**PERMIT ISSUED**  
Permit Number: 051745  
JAN 18 2006  
**CITY OF PORTLAND**

**Addendum #2:**

**Project:** 254-256 Danforth Street, Portland, Maine  
Apartment Renovation

**Addendum #1:**  
December 7, 2005

**SK-1: Foundation Drainage Detail**

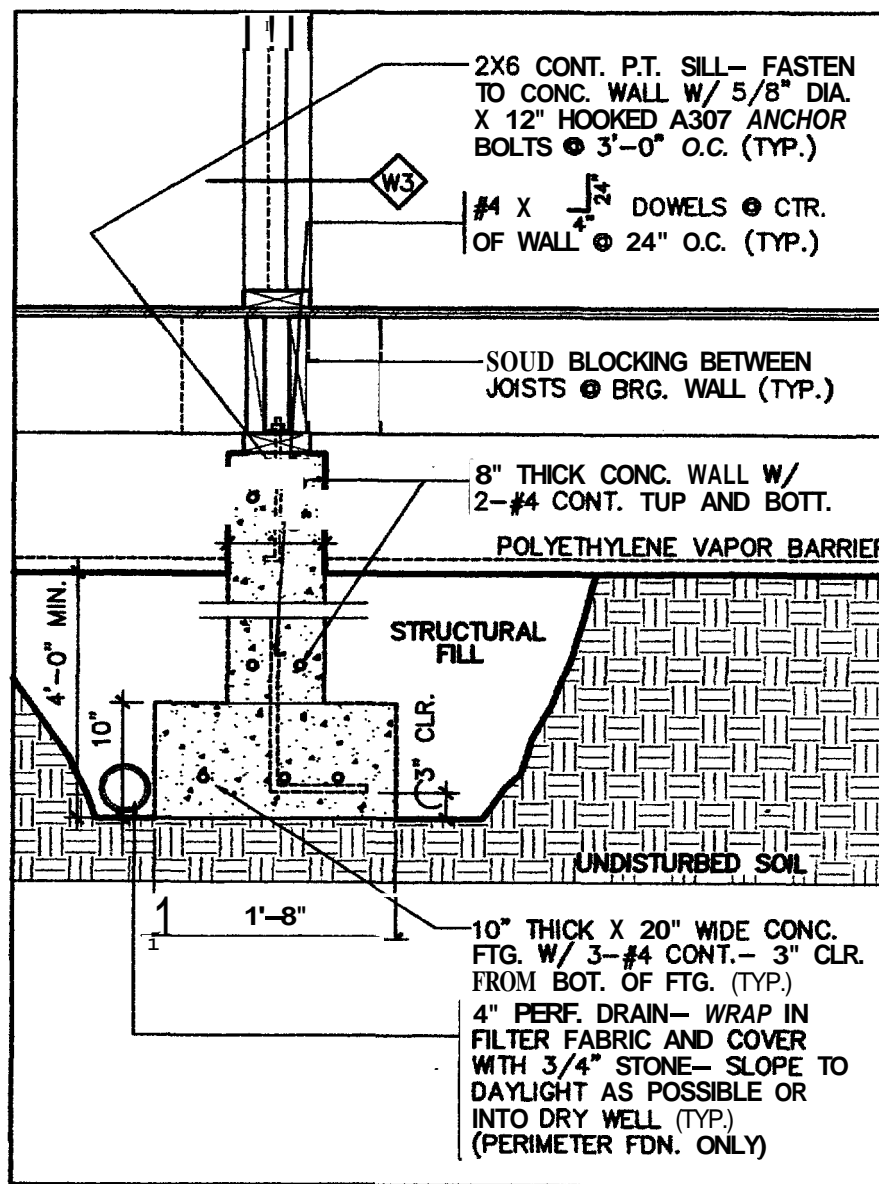
3. **Sheet E1** is being resubmitted to show the location of the smoke detectors.
4. **SK-1** shows the typical foundation drainage for the perimeter foundation wall.

**SK-2c:** Fire rated wall assembly revisions & STC ratings

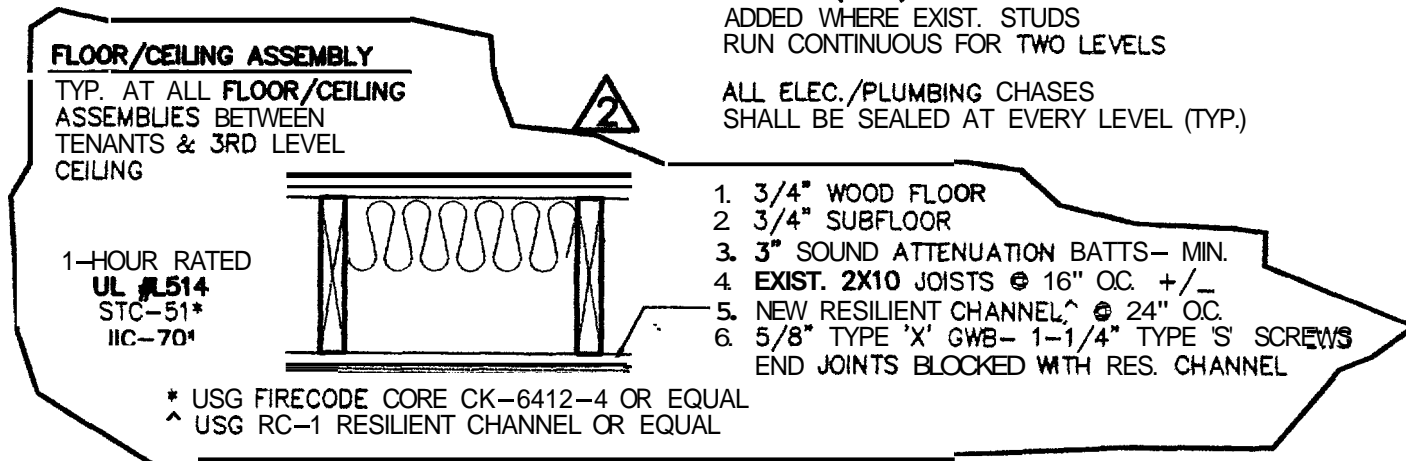
5. **SK-2(a,b,c)** show revisions to the fire-rated wall assemblies in order to meet the I.B.C. required STC rating of 50 required on all walls/ceilings separating tenant spaces from other tenants or public areas/pathways.

ALL NEW VENTS (BATH/DRYER/RANGE HOOD) MUST VENT TO **ME** OUTSIDE WALL UNDERNEATH THIS RATED CLG. ASSEMBLY & *SHALL* NOT PENETRATE THROUGH IT.

PENETRATIONS INTO BASEMENT FROM FLOOR ABOVE SHALL BE SEALED WITH A MIN. 5/8" TYPE 'X' AND SEALED AGAINST ADJACENT MATERIAL WITH FIRE CAULK (TYP.)

FIRE BLOCKING IS NECESSARY FOR ALL WALLS AT EACH FLOOR- (TYP.) THIS SHALL BE ADDED WHERE EXIST. STUDS RUN CONTINUOUS FOR TWO LEVELS

ALL ELEC./PLUMBING CHASES SHALL BE SEALED AT EVERY LEVEL (TYP.)

**SK-3:** Interior layout revision for the addition of new **gas** fireplace inserts @ all units.

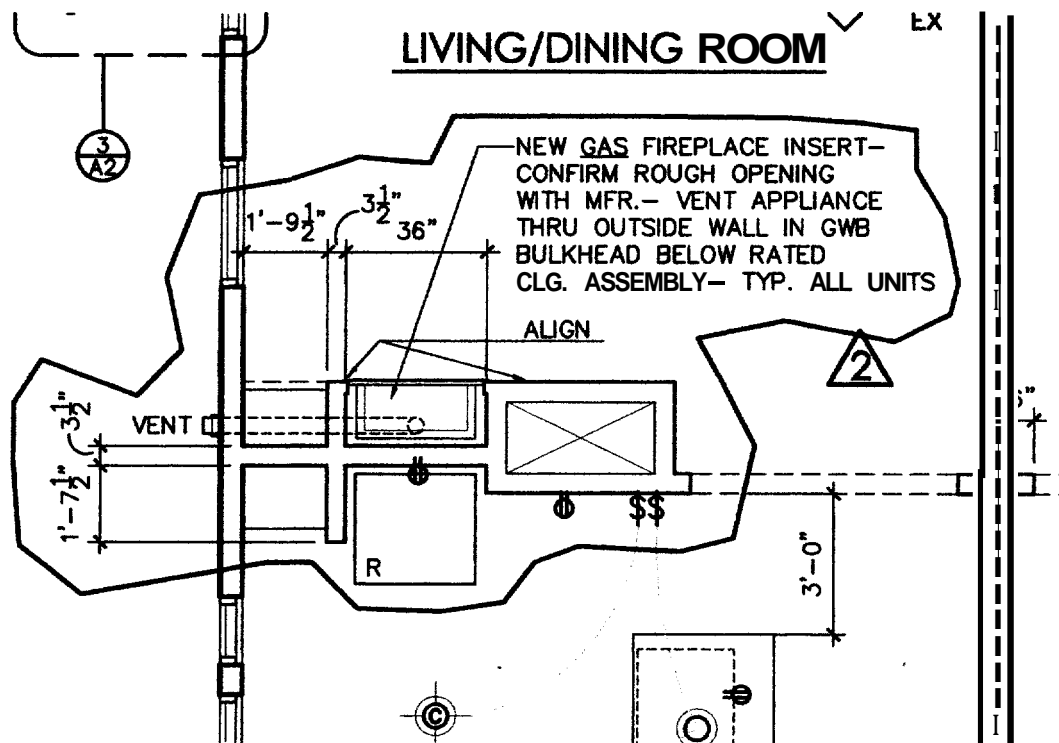
7. **SK-3** shows the revision to the interior layout for each of 6 units to include a gas fireplace insert. Venting will be taken care of directly to the outside wall below the rated ceiling assembly.

Location of drawing revision note # 1: **Sheet A1: Detail 4 "Proposed Basement Plan"**  
**Sheet L1 "Plot Plan"**

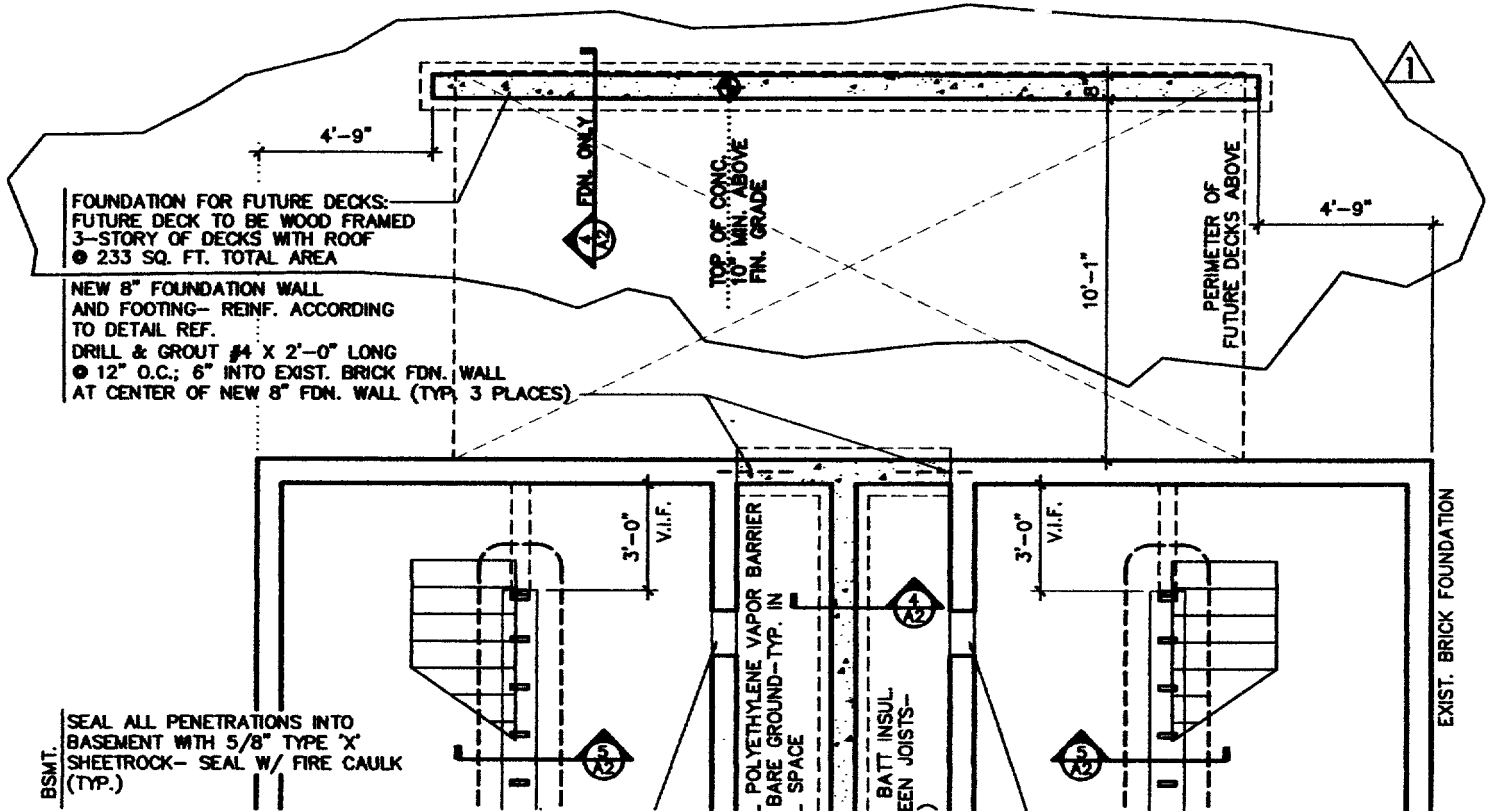
- The scope of the rear foundation wall, built to support 3 stories of wood-framed deck and roof (details will be described in Phase II of the renovation which has not yet been submitted for permit), has changed- see drawing for revised dimensions and height. The area of the future decks is shown as a revision on this plan.  
A new Plot Plan, sheet L-1 will be submitted as a part of this addendum.

Location of drawing revision note #2: **Sheet A1: Detail 1 "Proposed First Level Plan"**

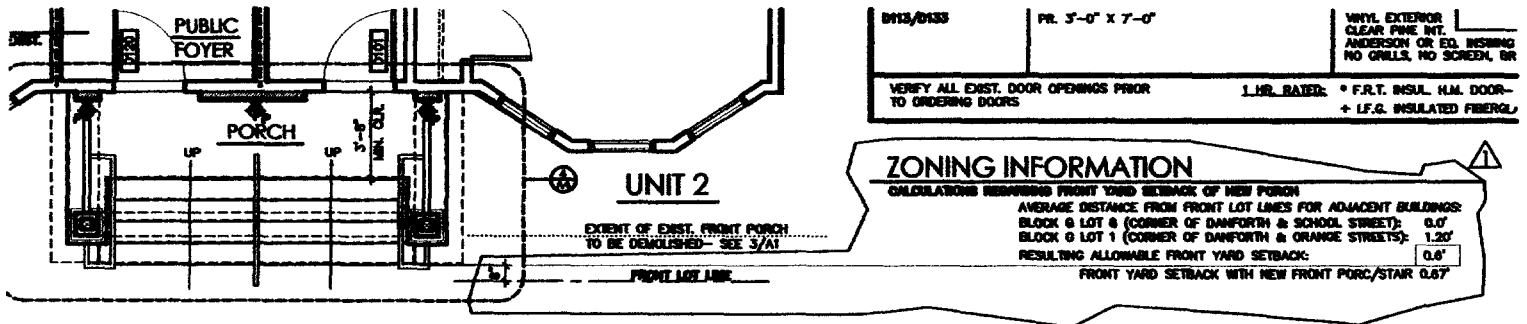
2 The zoning information has been revised to show that the full extent of the front stair is within the allowable front yard setback. See attached sketch which

Total Lot area (Boundary survey):	6,448 sf
R-6 allows 50% coverage of lot by building:	3,224 sf
Building area computations: (Architectural Plans)	
Gross area of building	2,818.2 sf
Side egress stairs (2@27.25 sf)	54.5 sf
Front porch/stairs	115.0 sf
New Rear decks	233.2 sf
<b>Total area of building</b>	<b>3,220.9 sf</b>
